Construction Division
Additions & Alteration Charges Approval Form

| Company Name: | MRMLLP | Site | Gulmohar Residency |
| Villa/ Flat No. | C-207. | | |

Details of Additions & Alterations

| Description | Direction | Owners & Developers : | Date | Promoted by |
|-------------------------------|-----------|---|--------------------------|-------------------------|
| WORKING PLAN-1660 Sft-B1 TYPE | N | Modi Reality Mallapur LLP Project Name & Phase : | 25.09.2020 | Modi Properties Pvt Ltd |

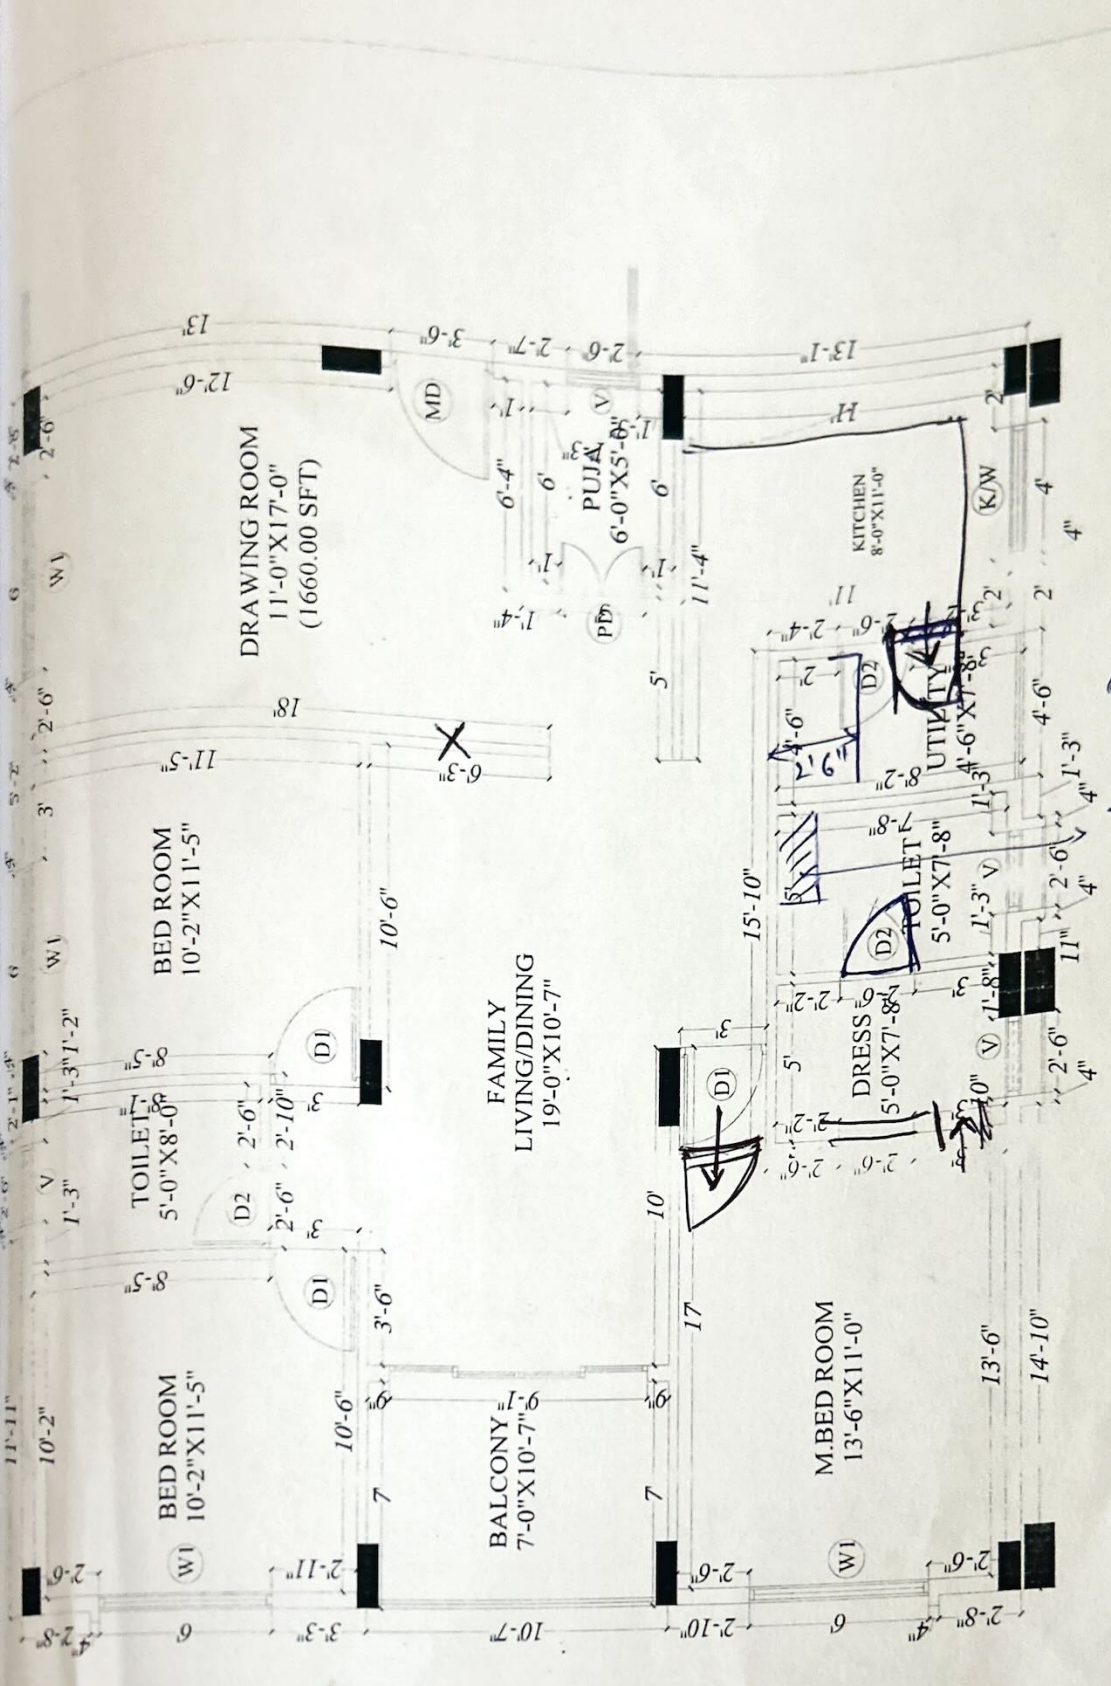
① ACB to be shifted as in plan.

①. platform to be extended till the wall.
with patti of 3"

1. Partition: 6'3" not required.
2. Dressing room to be moved towards right.
3. M.B. door to be shifted as mentioned in plan.
4. Utility to be moved right side alignment for platform.
- 5.

PLUMBING PLAN-1660 Sft (B1-TYPE)

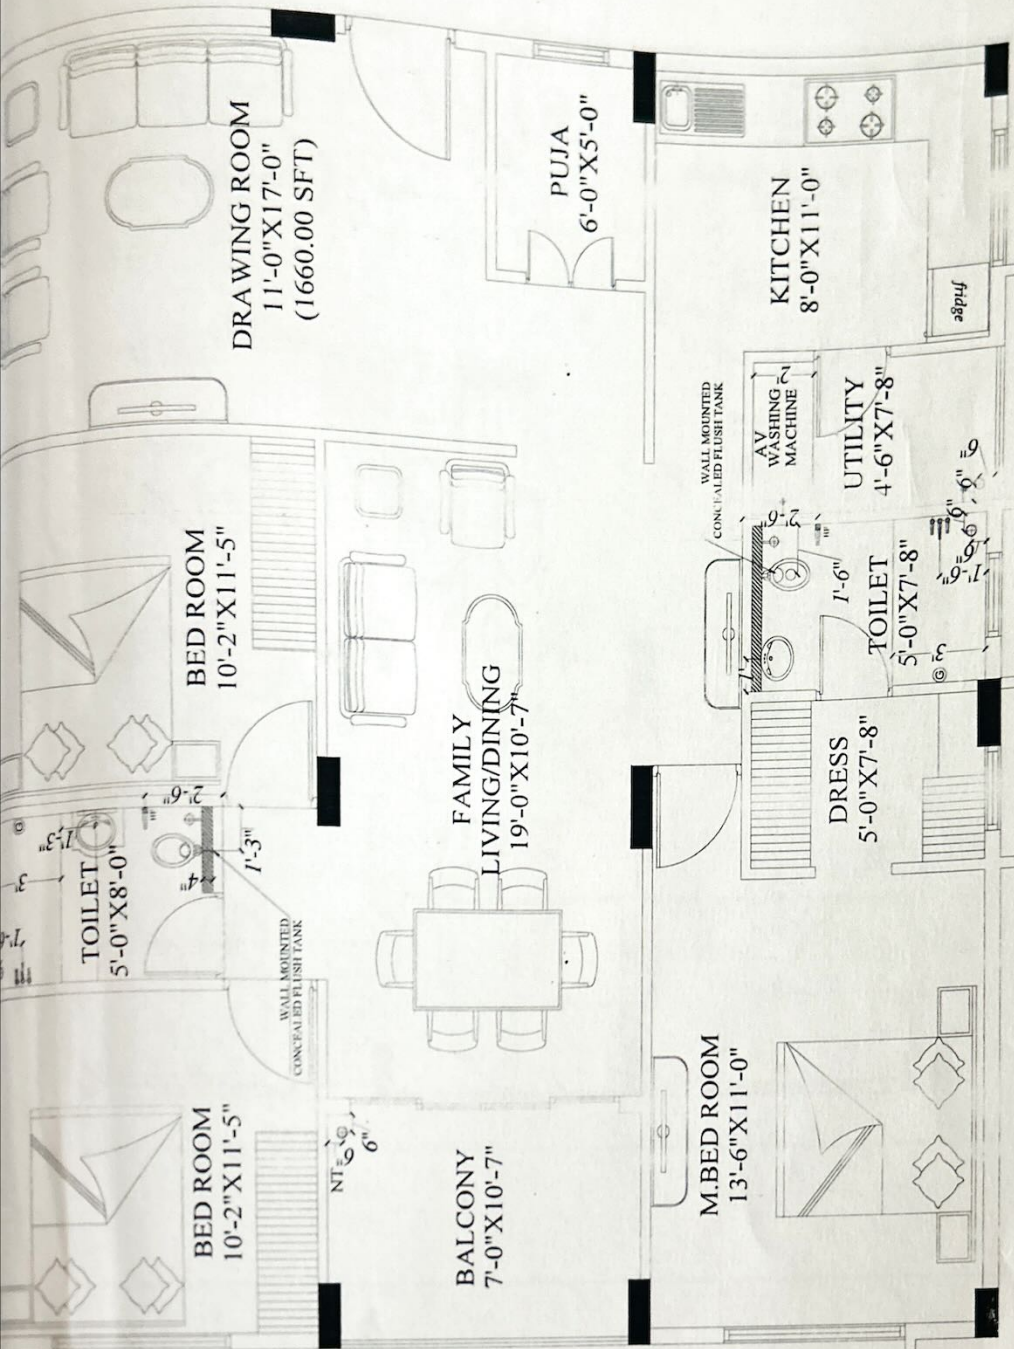
NOTE :- 1) In c. Toi, The shower & geyser angle cork to be placed at [6'3"] instead of [6'6"].
